SEWAGE INSTALLATION

FORM 20103-0477
REQUEST FOR SITE CLEARANCE AND PERMIT FOR INDIVIDUAL SEWAGE DISPOSAL SYSTEM
City Ordinance No. 9150 ☐
County Resolution No. 2832 ☒

Legal Description T9N - R8E - Sec 27 Location [redacted] & Hwy 2

WELL/SEWAGE SYSTEM INSPECTION FORM

TYPICAL INDIVIDUAL SEWAGE SYSTEM DESIGN

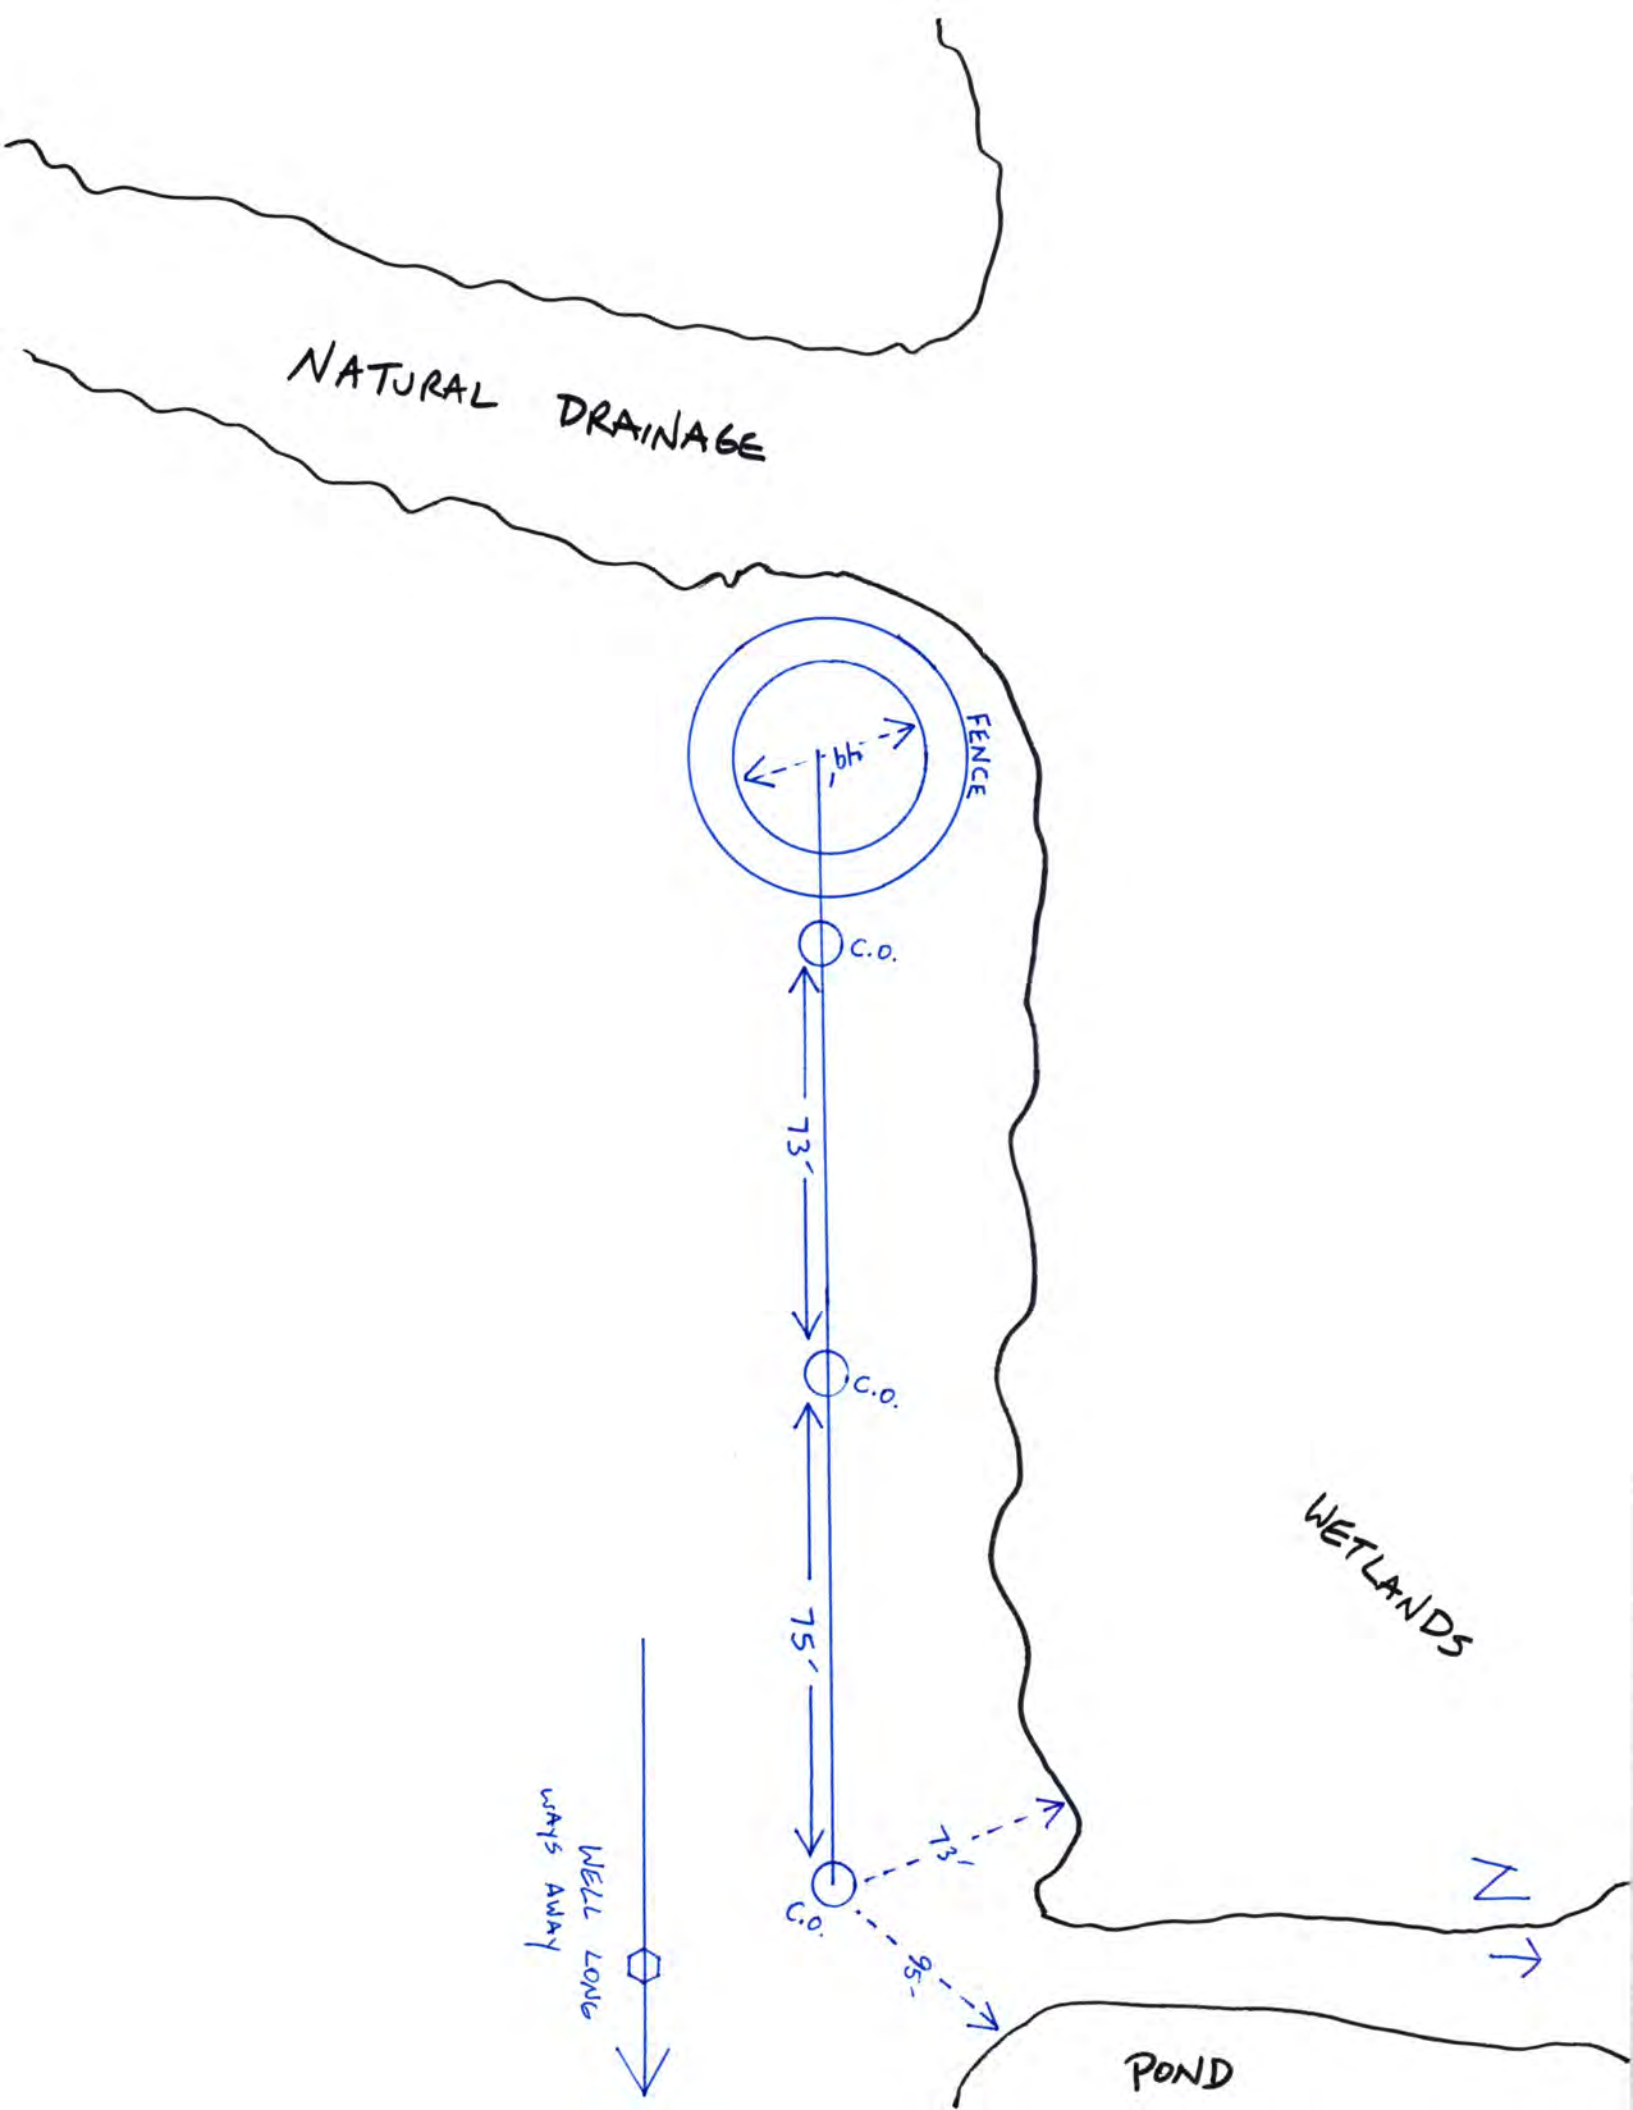
NATURAL DRAINAGE
FENCE
49'
C.O.
73'
C.O.
75'
C.O.
73'
95'
WELL LONG WAYS AWAY
WETLANDS
POND
N

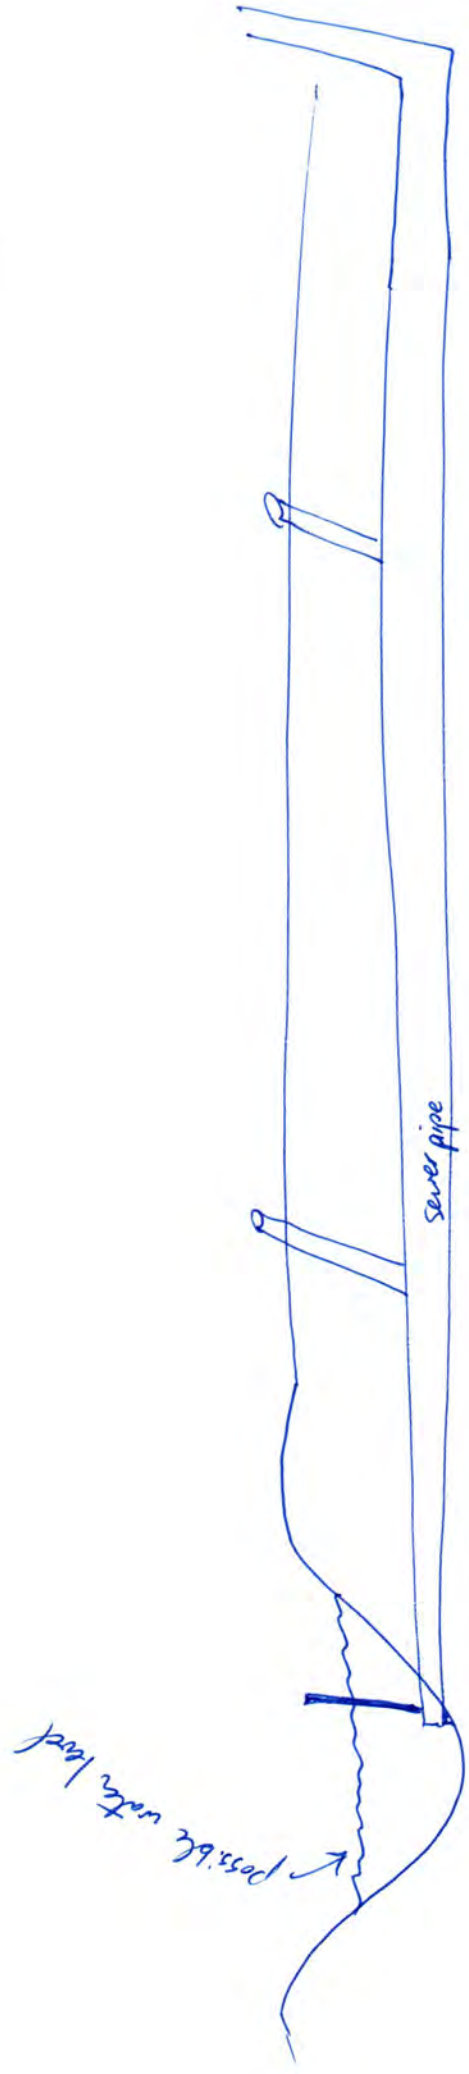
(11) Sewer pipe has 1/8" drop all the ways from house access pipe. Informed Mr. Beavers that this pipe would contain water w/ head pressure from lagoon at all times (dia. on reverse)

sewer pipe
possible water level
